Liberty School District – Storm Shelter Additions
Addendum No: 005
Description Narrative
October 06, 2023

Revised architectural sheets G102, A101A, A121A, A141, A332, A662

M101A

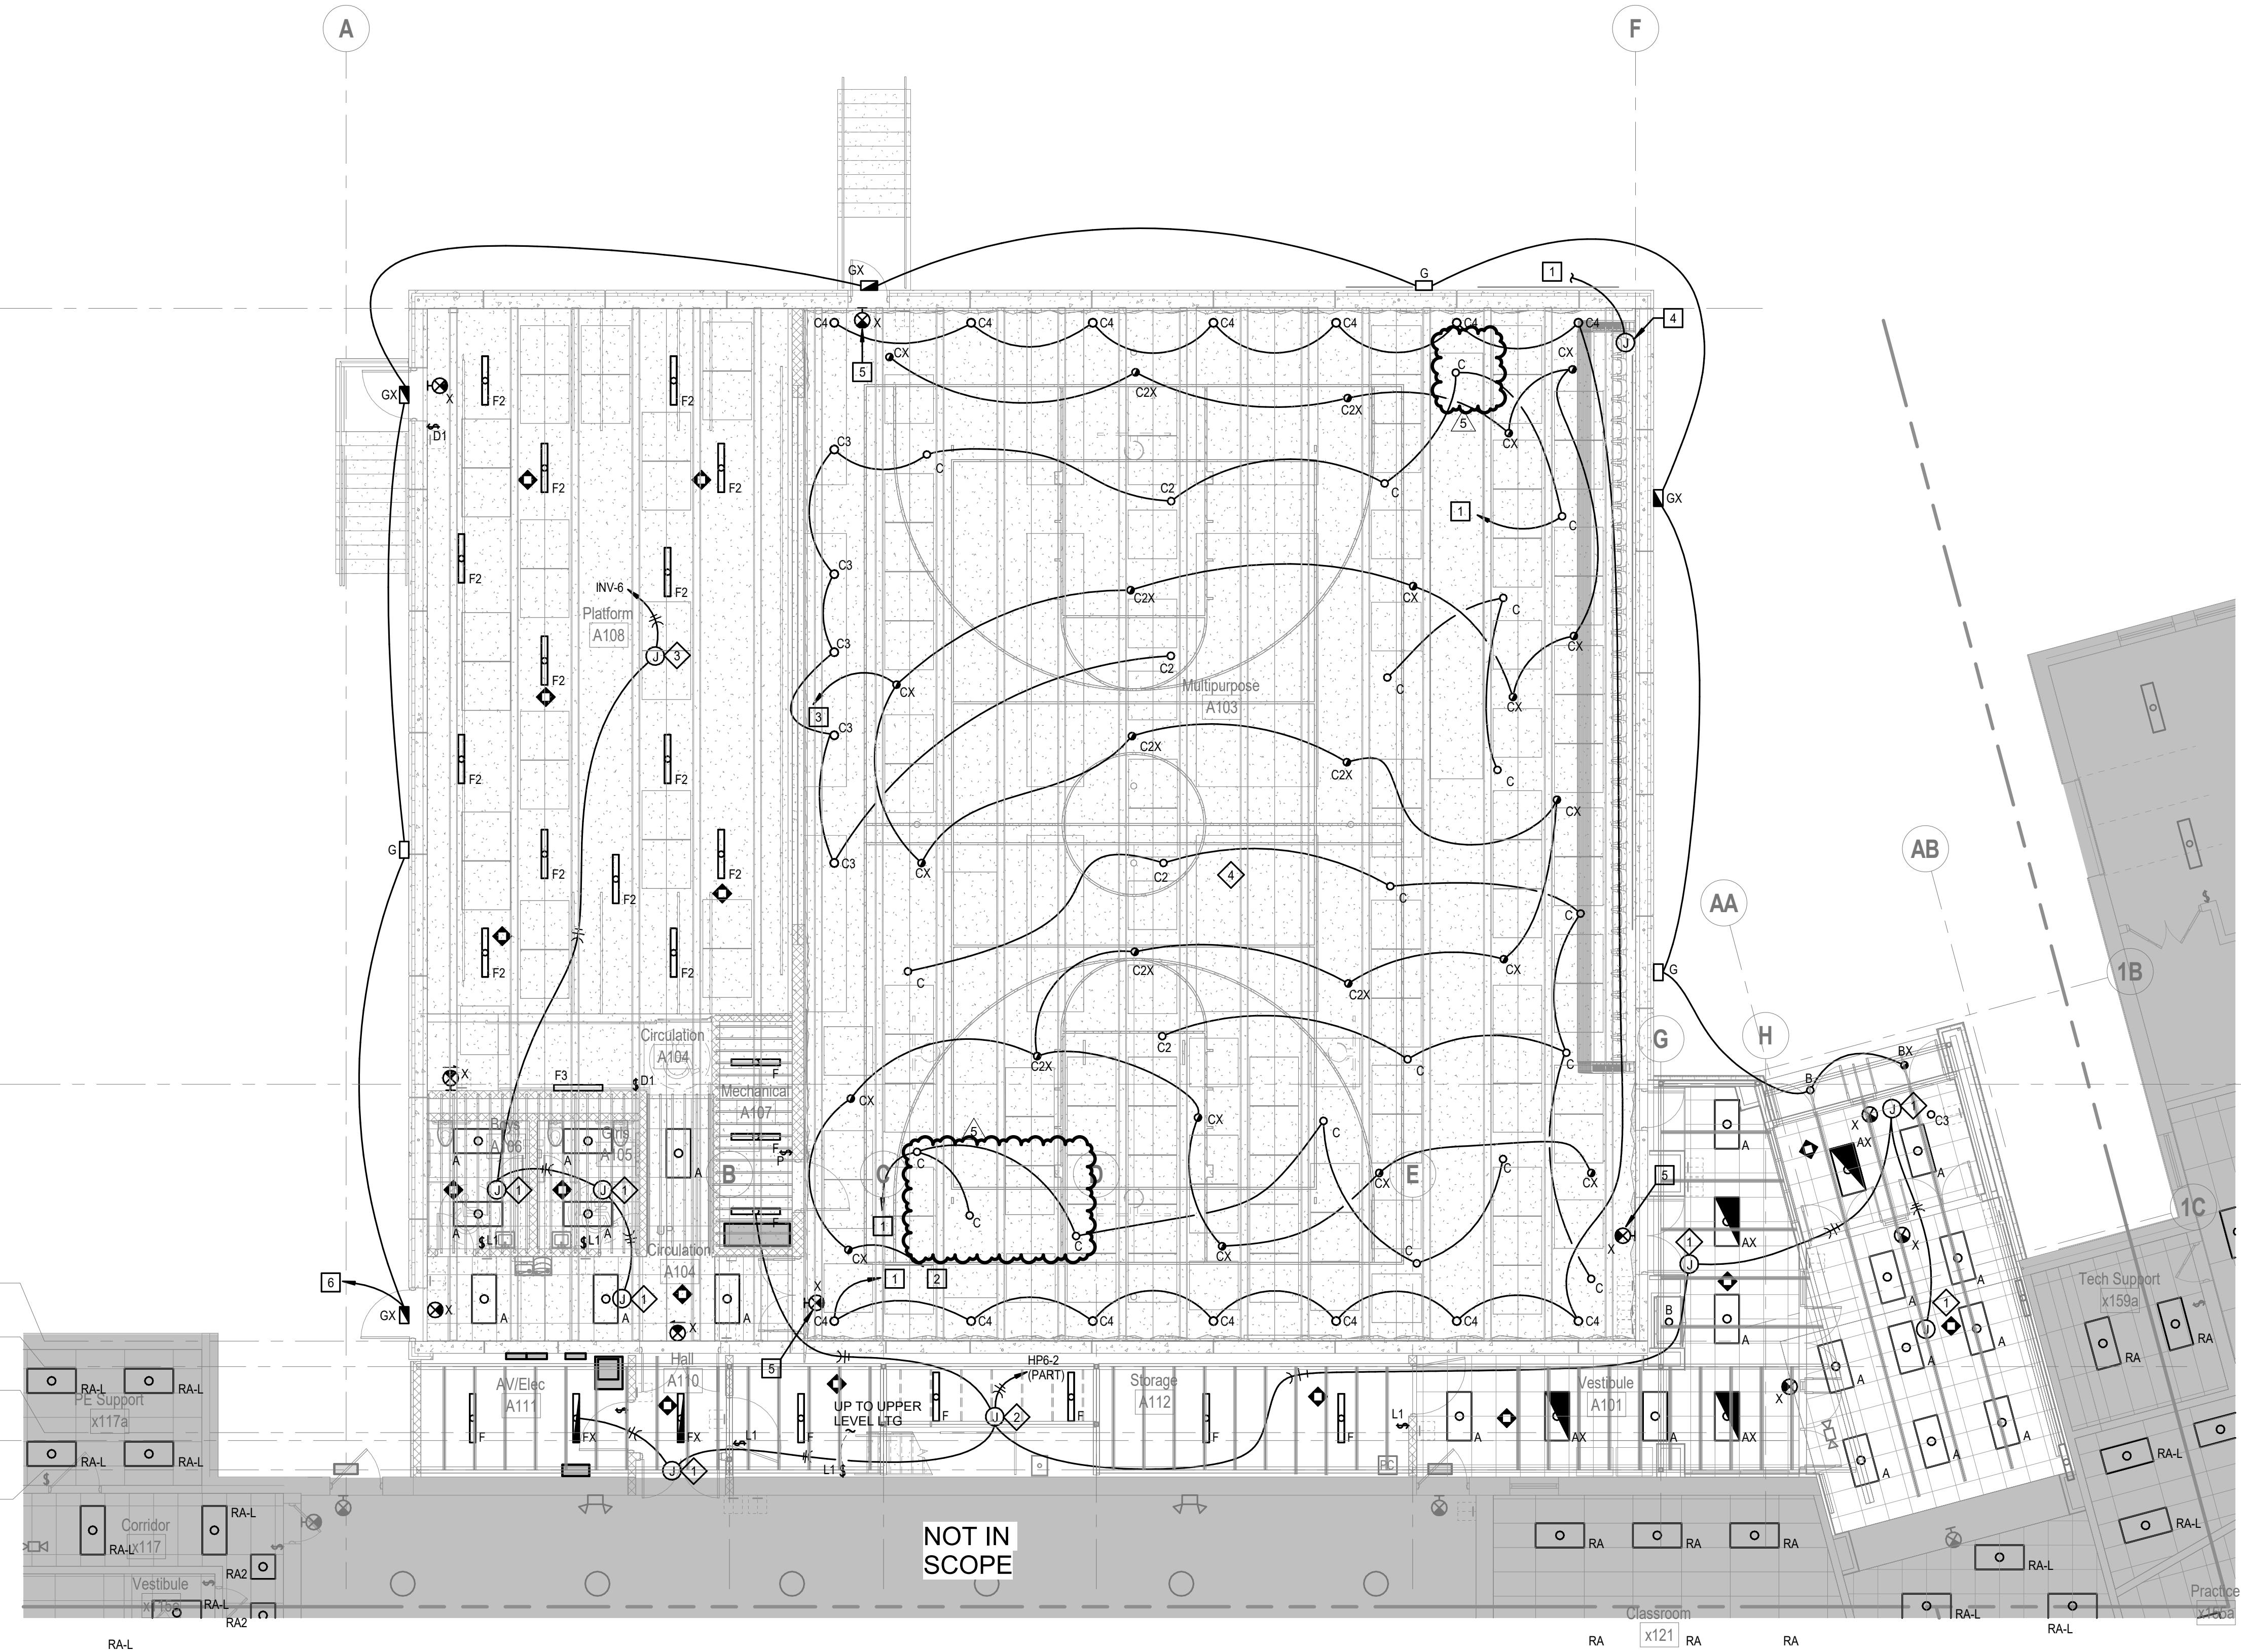
- d. Add L-5 through L-6 to the Louver Schedule.
3. Sheet M101A – HVAC Plan – Level 1 & Mezzanine – Area A
 - a. Revise plan notes 2, 3, and 4.
 - b. Remove shrouds and replace with ICC 500 rated louvers at rooftop unit duct penetrations and revise associated ductwork.

E302

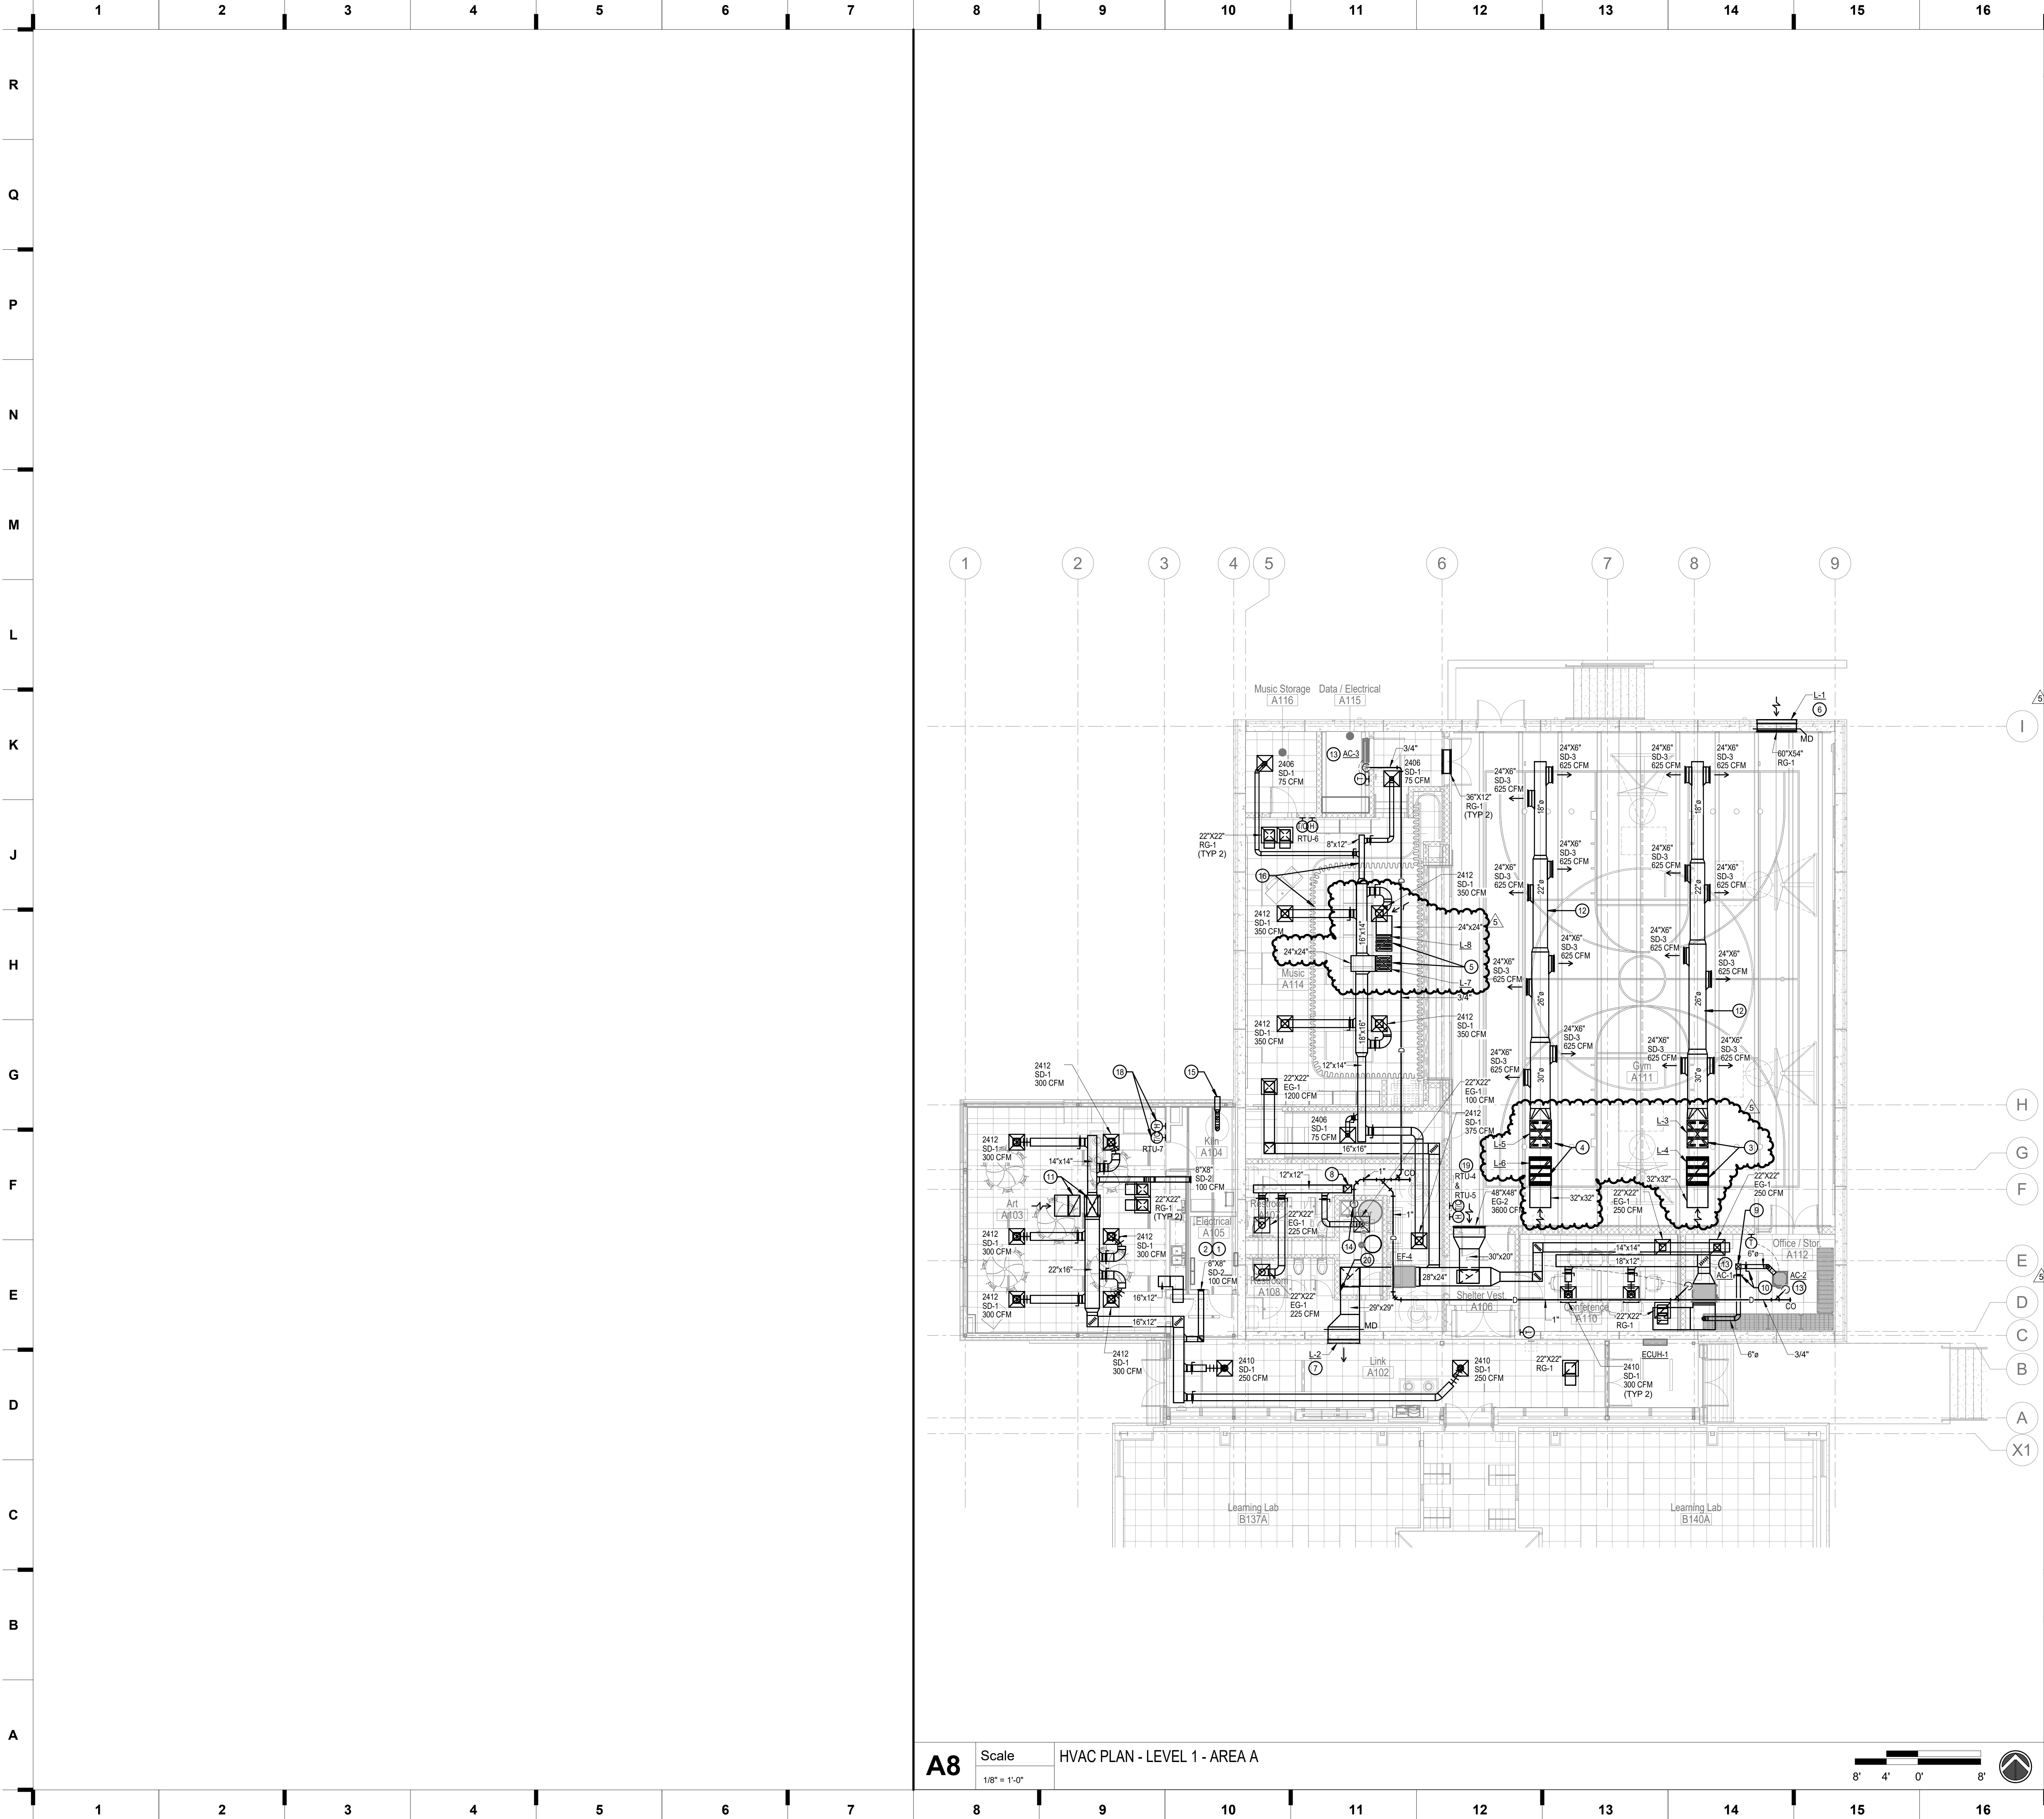
5. Sheet E302 – Electrical Schedules and Details
 - a. Added in manufacturers for type C3 and C4.
